**STAFF RECOMMENDATION**

**215 Broadway  
May 19, 2021**

**Application:** New Construction—Addition  
**District:** Broadway Historic Preservation Zoning Overlay  
**Council District:** 19  
**Base Zoning:** DTC  
**Map and Parcel Number:** 09306404300  
**Applicant:** Feltus Hawkins Designs  
**Project Lead:** Melissa Sajid, [Melissa.sajid@nashville.gov](mailto:Melissa.sajid@nashville.gov)

<p><b>Description of Project:</b> The application is to install a wall and clock on an existing rooftop addition.</p> <p><b>Recommendation Summary:</b> Staff recommends disapproval, finding that the project does not meet Section III.I (additions to existing buildings) of the <i>Broadway Historic Preservation Zoning District: Handbook and Design Guidelines</i>.</p>	<p><b>Attachments</b> <b>A:</b> Examples <b>B:</b> Plans</p>
--	--

Figure 4. View of 217 Broadway from rooftop deck at 215 Broadway.

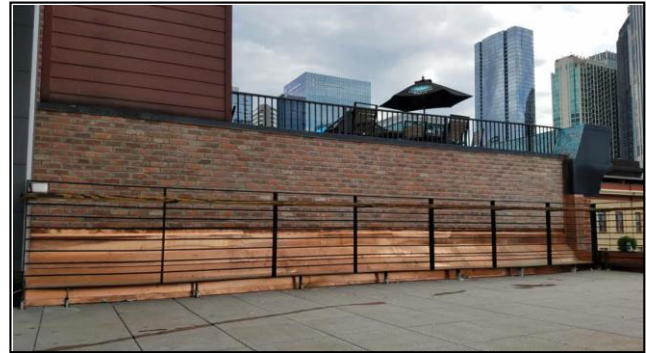
The existing roof patio has a depth of thirty-three feet, nine inches (33'-9"), and the existing railing extends nearly to the front wall which does not meet the eight foot (8') setback for railings as it was permitted prior to the expansion of the overlay. The proposed wall would extend to the front of the building, forward of the existing railing. Given the height of the wall, staff evaluated the new construction as an addition rather than a railing. The design guidelines require that additions be set back thirty feet (30') from the main wall of the building, so the proposed wall does not meet the design guidelines. If the new construction were to be assessed as a railing, it would not meet the required eight foot (8') setback from the main wall, and the proposed clock would meet the design guidelines since railings are not supposed to support additional elements. As proposed, the new construction does not meet Section III.I of the design guidelines for additions to existing buildings.

FLOOR PLAN

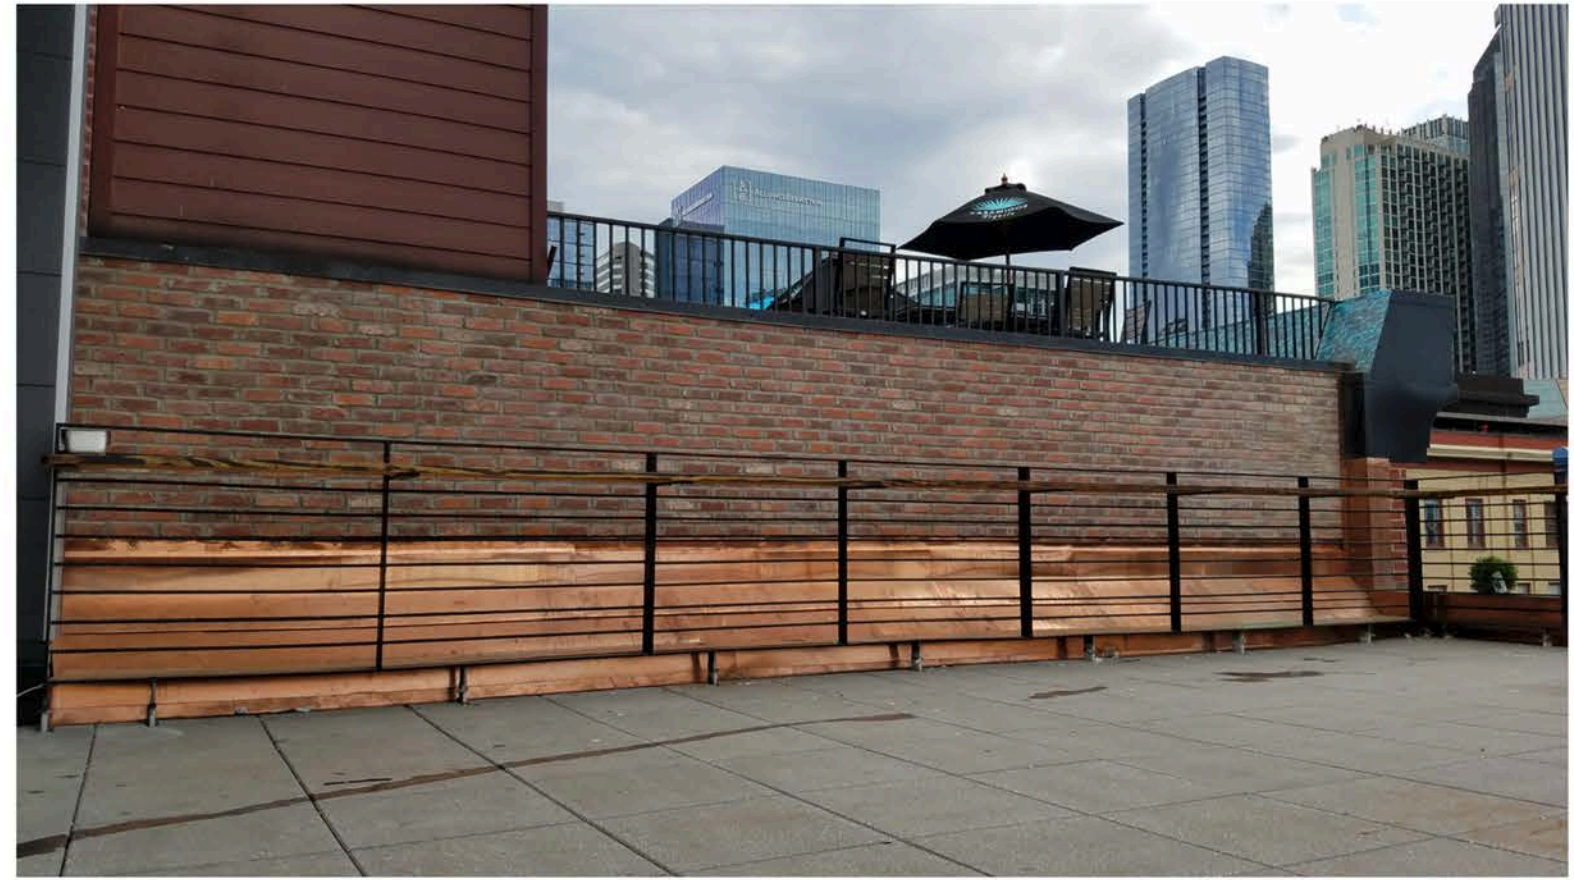
**Location:** The application is to install a nine foot, six inch (9'-6") tall perforated wall and clock element between the existing railing and the non-contributing building at 217-221 Broadway (currently Kid Rock's) (Figure 2). The side walls of the building at 217 Broadway sit eight feet (8') taller than the historic building at 215 Broadway (Figures 3-4), and the purpose of the proposed wall is to discourage patrons from jumping from the rooftop at 217 Broadway to the rooftop of the subject property.

**Recommendation:** Staff recommends disapproval, finding that the project does not meet Section III.I (additions to existing buildings) of the *Broadway Historic Preservation Zoning District: Handbook and Design Guidelines*.
